Access Compliance Report Public Rights-of-Way (Curb Ramps)

Main Street: DORRANCE_DR		Cross Street: DORRANCE_DR		Location:	E
ADA ID: RPRK211115114659	Ramp Type:Type 1 - Perpendicular	Initial Pass/Fail: Fail	Overall Compliance: No	Severity Score:	15

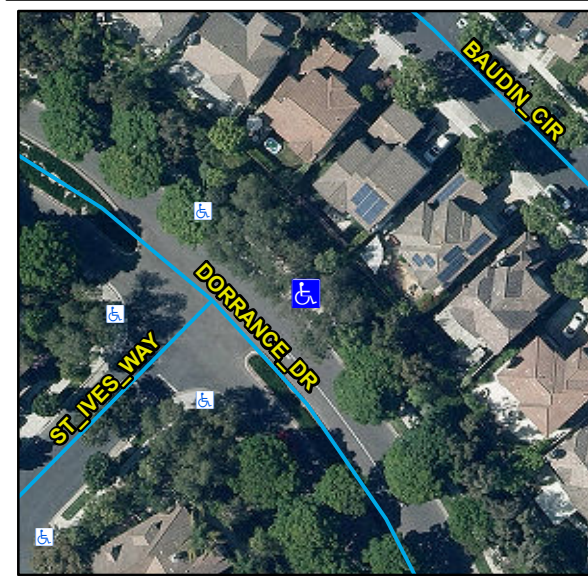
R304.2.2, R204.3, STD 1115

Compliance	Description	Data	Compliance	Description	Data
N/A	Ramp Length (in)	78	N/A	Flare Type LT	
Yes	Ramp Width (in)	48			N/A
No	Ramp Run Slope (%)	10.8	N/A	Flare Slope LT (%)	N/A
Yes	Ramp Cross Slope (%)	1	N/A	Flare Traversable LT	N/A
N/A	Landing Present	N/A	N/A	Flare Type RT	
N/A	Landing Length (in)	N/A			N/A
N/A	Landing Width (in)	N/A	N/A	Flare Slope RT (%)	N/A
N/A	Landing Run Slope (%)	N/A	N/A	Flare Traversable RT	N/A
N/A	Landing Cross Slope (%)	N/A	N/A	DWS Provided	N/A
N/A	Landing Movement Obstructed?	N/A	N/A	DWS Contrast	N/A
	Landing Movement Type	N/A	N/A	DWS Length (in)	N/A
N/A	Landing Shared	N/A	N/A	DWS Full Width	N/A
N/A	Clear Space	N/A	N/A	DWS Offset Left (in)	N/A
N/A	Clear Space To Crosswalk (in)	N/A	N/A	DWS Offset Right (in)	N/A
N/A	Marked Crosswalk 1	No	N/A	Marked Crosswalk 2	N/A
	Crossing 1 Direction	SW		Crossing 2 Direction	N/A
	Marked Crosswalk 1 Width (in)	N/A		Marked Crosswalk 2 Width (in)	N/A

N/A	Ramp Inside Crosswalk 1	N/A	Yes	Ramp Inside Crosswalk 2	N/A
	Crossing 1 Slope (%)	2.2		Crossing 2 Slope (%)	N/A
	Crossing 1 Cross Slope (%)	2		Crossing 2 Cross Slope (%)	N/A
N/A	Gutter Ponding	N/A	No	Curb Slope	14.4
Yes	Gutter Lip Height (in)	0		Road Run Slope (%)	N/A
N/A	Gutter Run Slope (%)	N/A		Road Cross Slope (%)	N/A
N/A	Gutter Cross Slope (%)	N/A			
Yes	Overall Surface Condition: Acceptable		No	Perp Joint Present	No
	Cross Gutter Present?	No		Spandrel Present?	No
	Replace Cross Gutter?	N/A		Replace Spandrel?	N/A

Remove & Replace Entire Ramp.
